**ITB #2025-018906**

## **HOVLAND HALL WEST WING REMODEL CONSTRUCTION SERVICES**

### **ADDENDUM NO. 1**

OSU Hovland Dry Lab Remodel

A-900

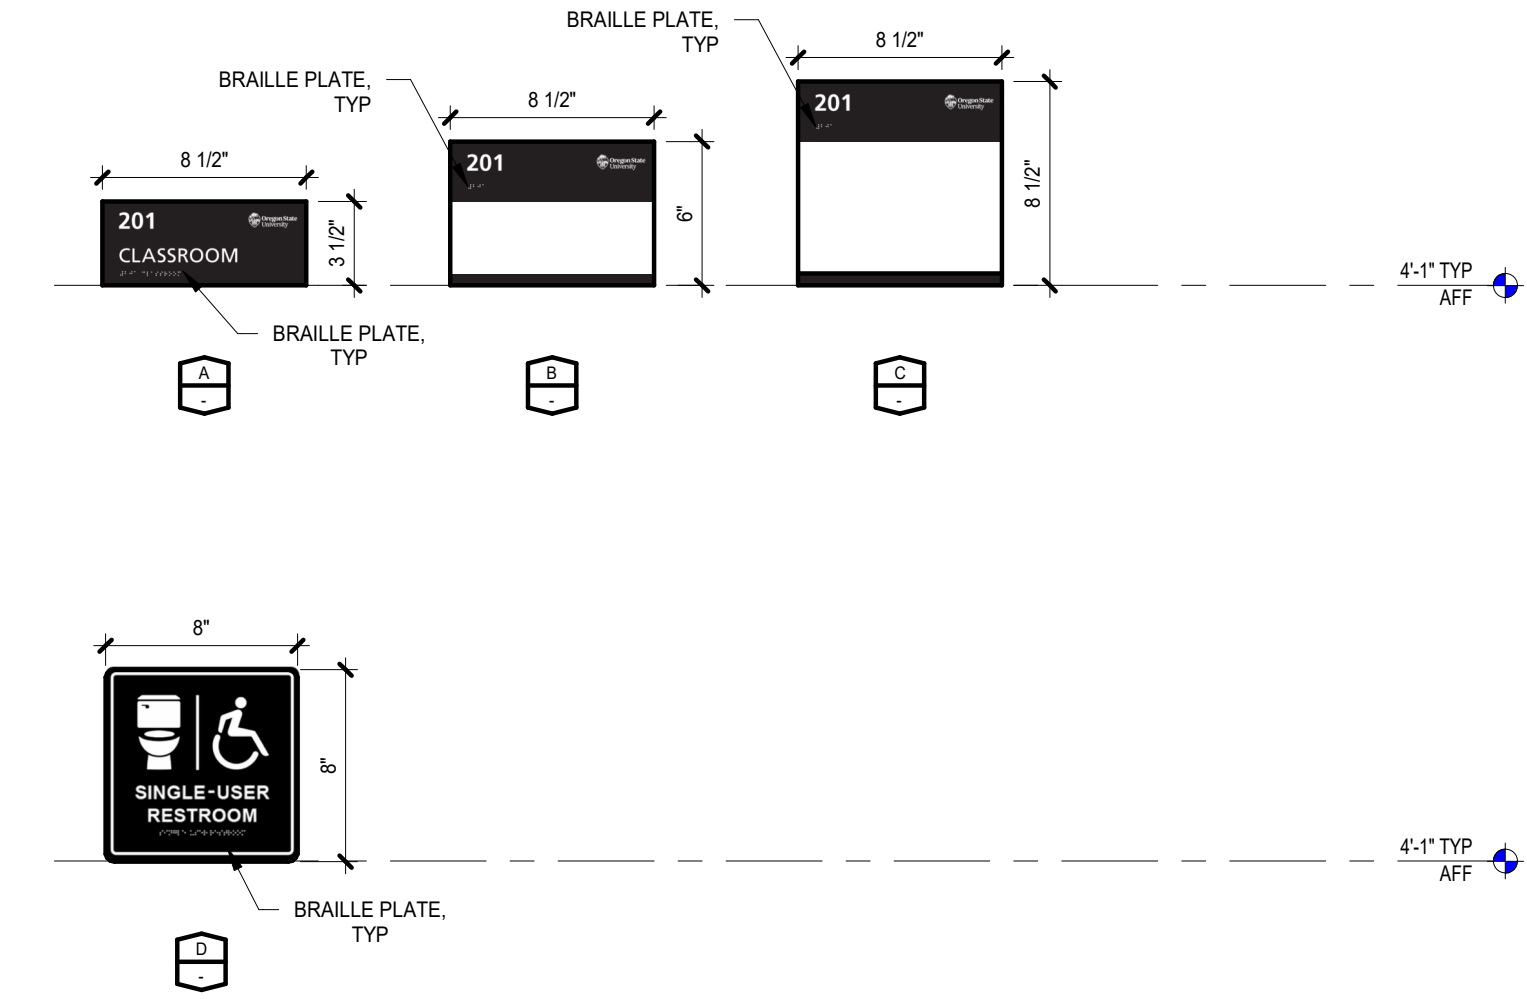
- 7) Sheet A-701 (re-issued, attached). Revisions include:
  - a) Finish Legend Revised as shown.
  - b) Finish Plan revised as shown.
- 8) Sheet A-900 (re-issued, attached). Revisions include:
  - a) Signage Plan revised as shown.
- 9) Sheet M-201 (re-issued, attached). Revisions include:
  - a) Level 1 Mechanical Plan revised as shown.
  - b) Roof Plan added.
  - c) Sheet Keynotes revised as shown.
- 10) Sheet A-300 (re-issued, attached). Revisions include:
  - a) Exhaust snorkel detail added.
